MCPB Item No. 3 Date: 04/17/2014

Saul Centers White Flint Sketch Plan No. 320140010

MB	Michael Brown, Planner Coordinator, Area 2 Division, Michael.Brown@montgomeryplanning.	org, 301.495.4566
	Khalid Afzal, Planner Supervisor, Area 2 Division, Khalid.Afzal@montgomeryplanning.org, 301.	
YK.	Glenn Kreger, Chief, Area 2 Division, <u>Glenn.Kreger@montgomeryplanning.org</u> , 301.495.4653	
		Completed: 04/04/2014

Circulation Plan

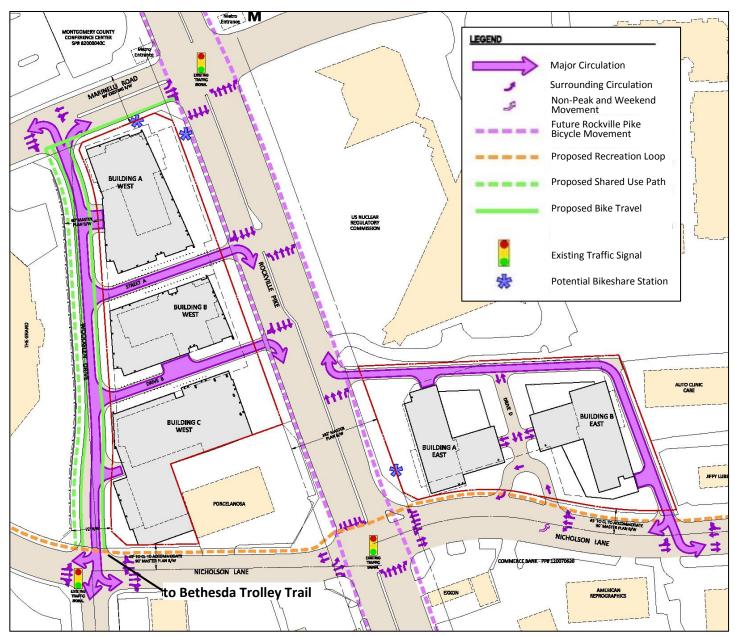
The sketch plan proposes development of two long, narrow sites with frontage along three public streets: Marinelli Road; Rockville Pike; and Nicholson Lane. Proposed private streets and master-planned right-of-way will divide the property into five smaller blocks. Woodglen Drive Extended will run along the western property line between Nicholson Lane and Marinelli Road. Proposed private *Streets A* and *B* between Rockville Pike and the proposed Woodglen Drive Extended will be the main access to the three buildings while a private driveway from Woodglen Drive will provide parking and loading access to Building C West.

Along the east side of Rockville Pike, *Street C* will run along the northern edge of the site abutting the NRC property. Two north-south connectors, *Drive D* and *Drive E*, are proposed to connect *Street C* and Nicholson Lane. These streets will provide access to service areas and parking facilities. All streets will have sidewalks and streetscape to support a walkable environment. The Project accomodates bike paths/lanes along frontages of Rockville Pike and Marinelli Road, as well as the recreation loop along Nicholson Lane as prescribed by the Sector Plan. Woodglen Drive extended will have a Shared Use Path on the west side with a bike lane on the east side. Connections to existing Metrobus and Ride On service will be provided via the pedestrian circulation system.
